PENROSE LIBRARY FENCE – FBZ WARRANT APPLICATION

Downtown Review Board - September 3, 2024

Staff Report by Case Planner: Johnny Malpica, AICP

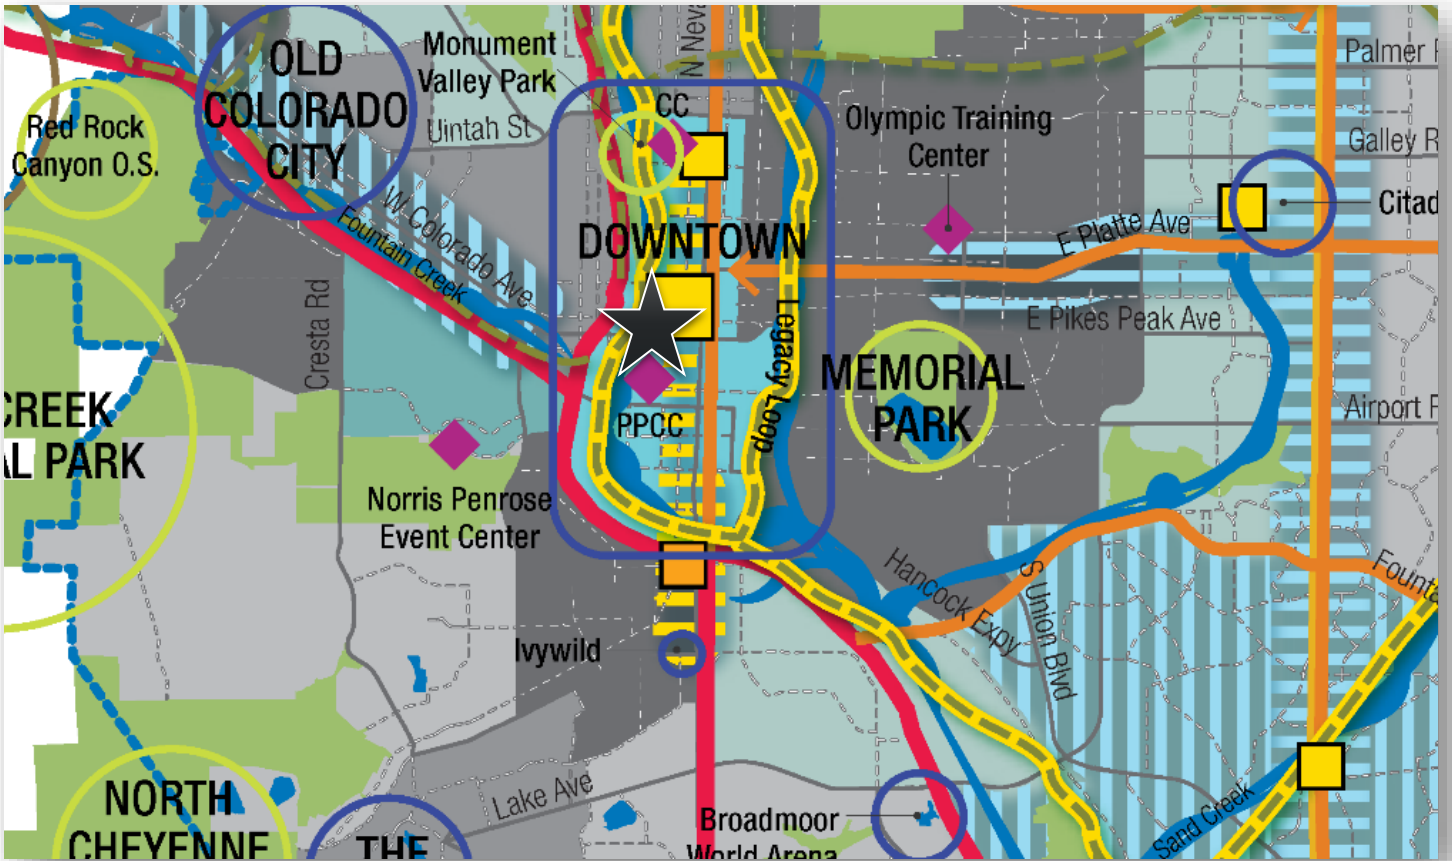
At the May DRB meeting, the Downtown Review Board considered alternative solutions and modifications to the proposal ensuring safety and comfort without compromising visual contiguity and the relationship of the site with the public realm. Those considerations required that the applicant engage in further consultation with Planning Staff to modify the proposal to limit enclosing the plaza space along N. Cascade Ave., as well as modifications to the fencing along the property line adjacent to W. Kiowa St., both of which serve as important pedestrian-oriented spaces within the Downtown. Following dialogue with City Staff, the applicant resubmitted a proposal on August 14, 2024. The revised plans included multiple notable design changes that still maintained the initial proposal’s intention to fence in the entire campus. However, both staff and DRB’s primary concerns were related to the enclosure of the public plaza space along N. Cascade. While the revised proposal still propositions to enclose this significant gateway area, it includes significant design enhancements that allow the space to feel more open, inviting, and visually contiguous with the surrounding landscape (See Figure 3). It should be noted that the revised proposal includes an increase in fence height from 7’ to 8’, however the increase in height is related to the new proposed fencing material so as to maintain sufficient security measures.

With consideration given to the above review criteria, the cultural significance of the Penrose Library, and its location and relationship to the pedestrian environment that surrounds it, Staff had initially concluded that the review criteria had not been met and suggested the proposal be modified to better meet the Common Lawn frontage standard and the criteria above. Considering the revisions made (See Figure 4 & 5), staff finds the proposal to be more aligned with the review criteria but suggests that the fence height be returned to 7’ throughout the perimeter, as was initially submitted. Furthermore, and specifically referencing the rearticulation of the enclosure of the plaza space, staff would suggest that the double wire fence be returned to 7’ in height, to ensure unobstructed visual contiguity. Along W. Kiowa St, staff suggests that the newly proposed double wire fence material be returned to the wrought iron style fence material that is 7’ in height, as initially submitted, and stepped back from the property line where possible. Finally, staff suggests that the plan and project statement be updated to include landscaping between the fence and the pedestrian way along portions of W. Kiowa St. to offset the imposing 7’ fence’s relationship to the pedestrian walkway.

Planning	<ul style="list-style-type: none"> - Reduce the fence height from 8' to 7'. - Step the fence back from the property line, where suitable to allow space for landscaping between the fence and the pedestrian ROW along W. Kiowa St. - Add landscaping along W. Kiowa St. Consider plant selections that have environmental benefit. - Replace the newly proposed 'Secur' (double wire fence) along W. Kiowa St, with the wrought iron style fence that is 7' in height, proposed in the initial submittal.
Fire	<ul style="list-style-type: none"> - Minor technical modifications. - Removal of two parking spaces to ensure adequate turnaround for fire apparatus vehicles. - Submittal of a separate permit through the Colorado Springs fire department, to be reviewed concurrently with this plan.
Enumerations	<ul style="list-style-type: none"> - Clarification regarding fencing height, that if 7' or over may require addressing.
